Informal document No. GRSP-44-01
(44th GRSP, 10-12 December 2008
agenda item 15(a))

Proposed amendments to the UNECE Regulation No. 29 on truck cab safety

Frontal impact

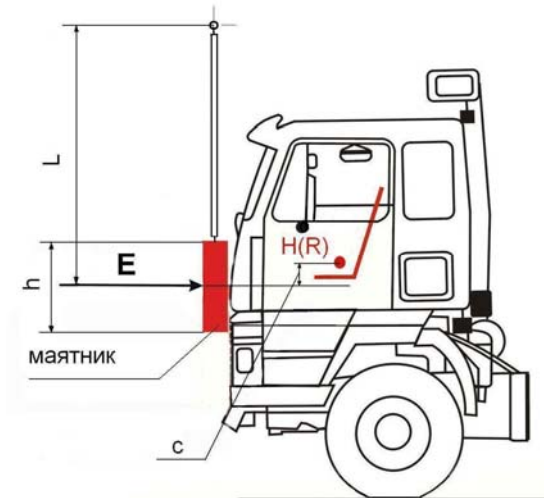
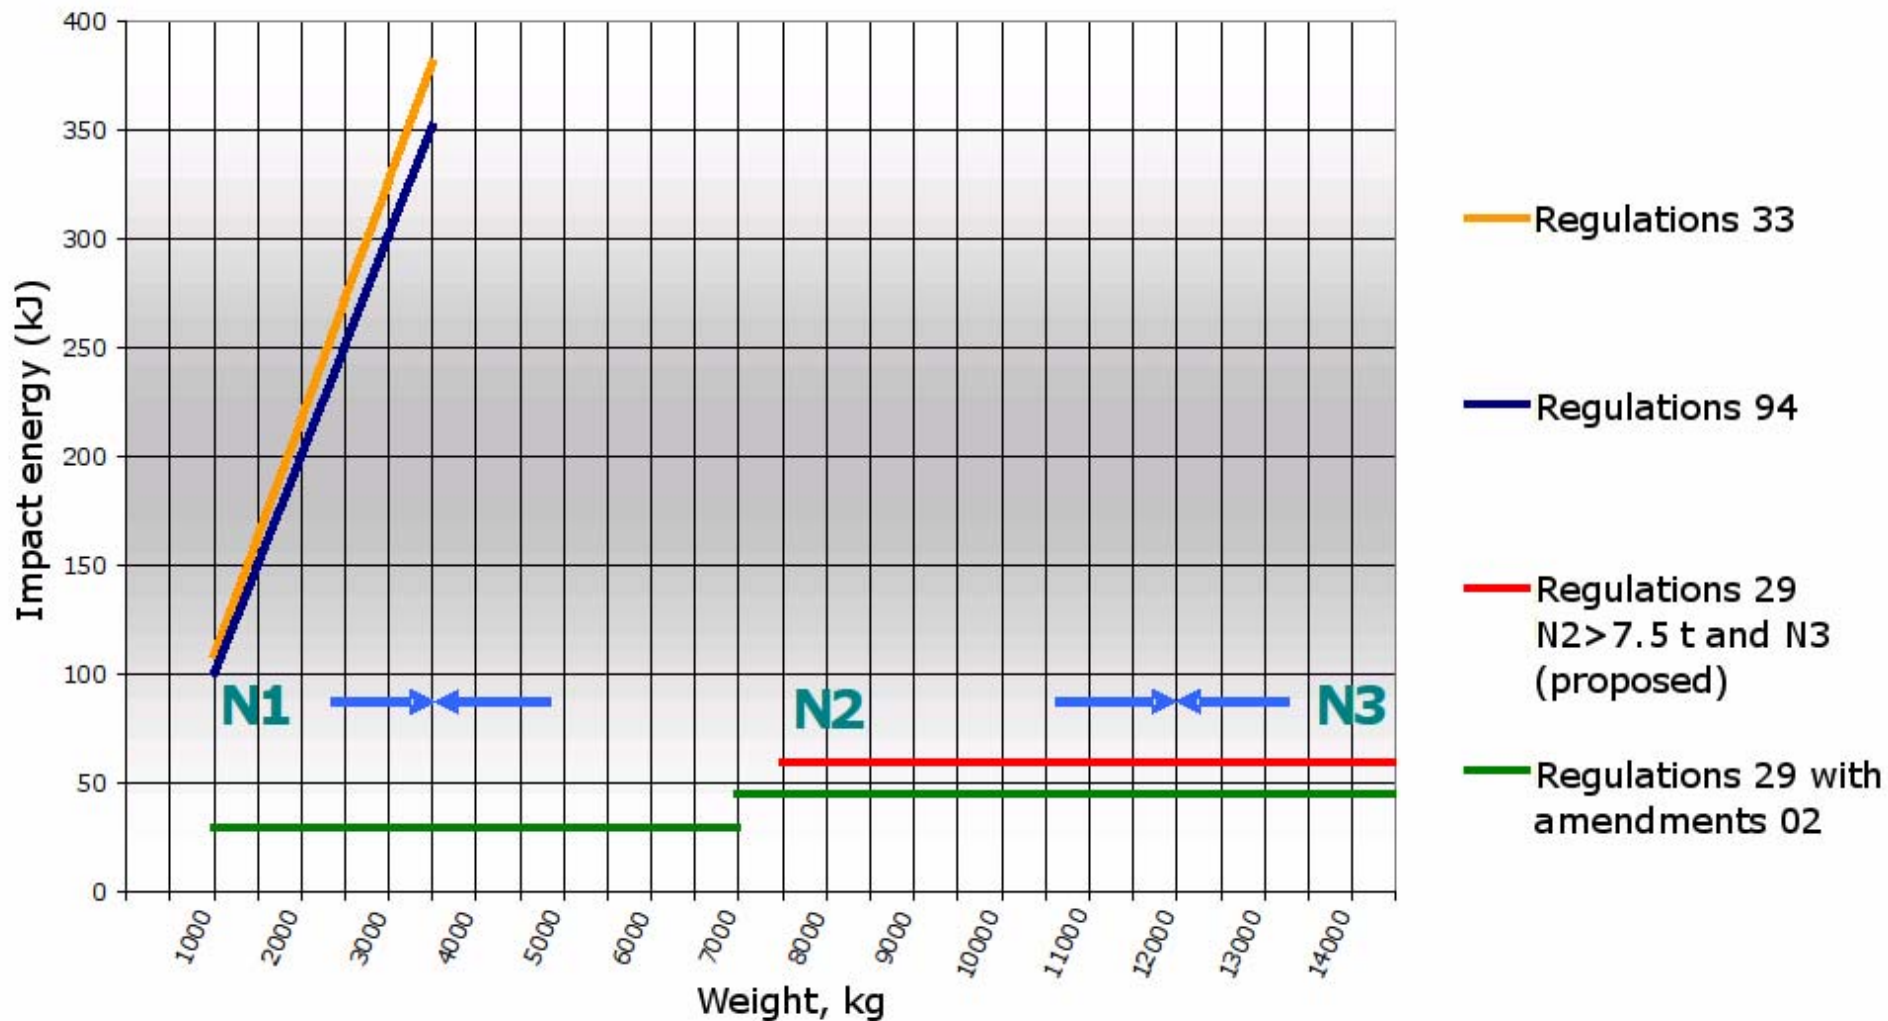
$N1$ and $N2 \leq 7.5 \text{ t} - \text{Regulations 29 with the 02 series of amendments}$

Alternative tests for $N1 - \text{Regulations 33 or 94.}$

Impactor energy:

- $N2 > 7.5 \text{ t and } N3 - 58.8 \text{ kJ}^*;$

- size: $h=800 \text{ mm}; l \geq 2500 \text{ mm}$
- mass $m = 1500 - 2500 \text{ kg}$

- $c=50 \pm 5 \text{ mm}$ ($50 \pm 5 \text{ mm}$ lower than point H (R))
- beam suspension of the impactor, $L \geq 3500 \text{ mm}, b \geq 800 \text{ mm}$

* - concerns only cab-over-engine and short bonnet vehicles; A truck is a bonnet truck if 75% or more of its engine length (excluding cooling systems) is located in front of the lowest rim of the wind shield. The length of the engine is limited by the clutch carter connector.

Front pillar impact

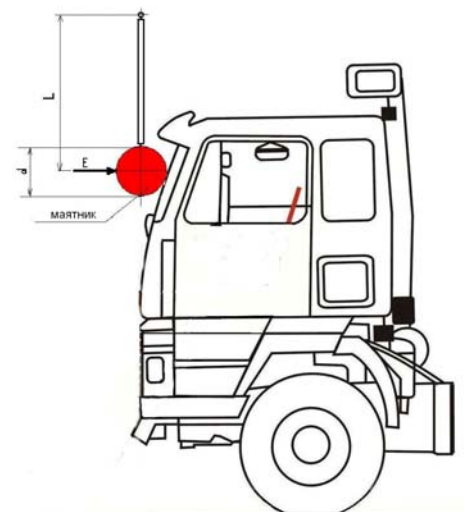
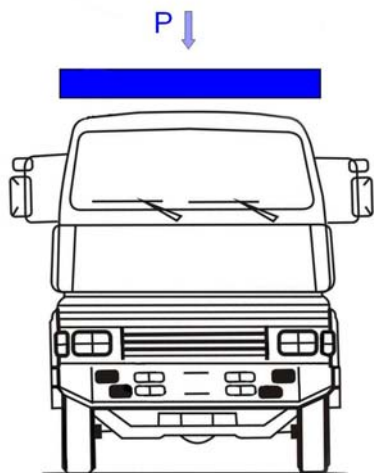
N1 and N2 \leq 7.5 t – Regulations 29 with the 02 series of amendments

- N2 > 7.5t and N3 – 29.4 kJ;

- size: $d=[300 - 600]$ mm; $l \geq 2500$ mm

- mass $m = 1000 - 1500$ kg

- The impactor must hit at the middle height level of the wind shield;

- beam suspension of the impactor, $L \geq 3500$ mm, $b \geq 800$ mm

Roof Strength

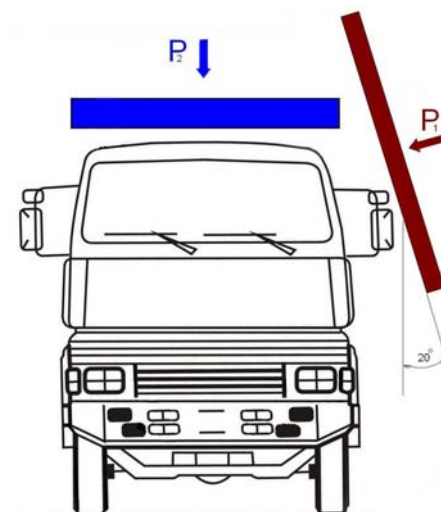
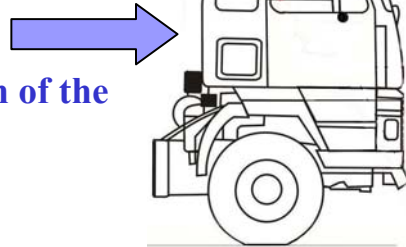
$N1$ and $N2 \leq 7.5 \text{ t}$ – Regulations 29 with the 02 series of amendments

- $N2 > 7.5\text{t}$ and $N3$ – 17.6 kJ;

-size: $h=800 \text{ mm}$; $l = 2500 \text{ mm}$

- mass $m = 1500 \pm 250 \text{ kg}$

-20 degrees relative to the vertical plane

- beam suspension of the impactor, $L \geq 3500 \text{ mm}$, $b \geq 800 \text{ mm}$

$$P = P_{\Pi} \leq 98 \text{ kN}$$

Back Wall Strength

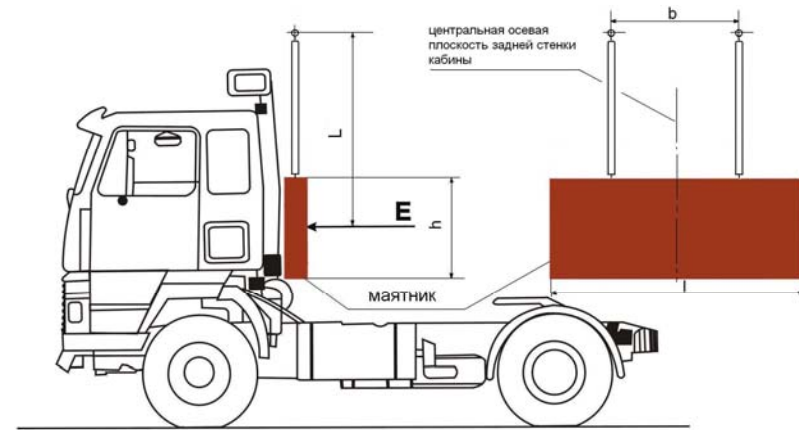
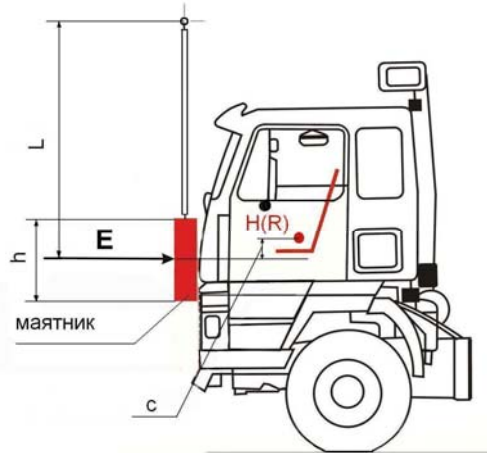
N1 and N2 ≤ 7.5 t – Regulations 29 with the 02 series of amendments

- N2 > 7.5t and N3 – 29.4 kJ;

- size: h=800 mm; l = 2500 mm

- mass m = 1500 \pm 250 kg

- the center of the impact must coincide with the central axial plane of the back wall and be located in the midpoint between the floor and the roof of the cabin;

- beam suspension of the impactor $L \geq 3500$ mm, $b \geq 800$ mm
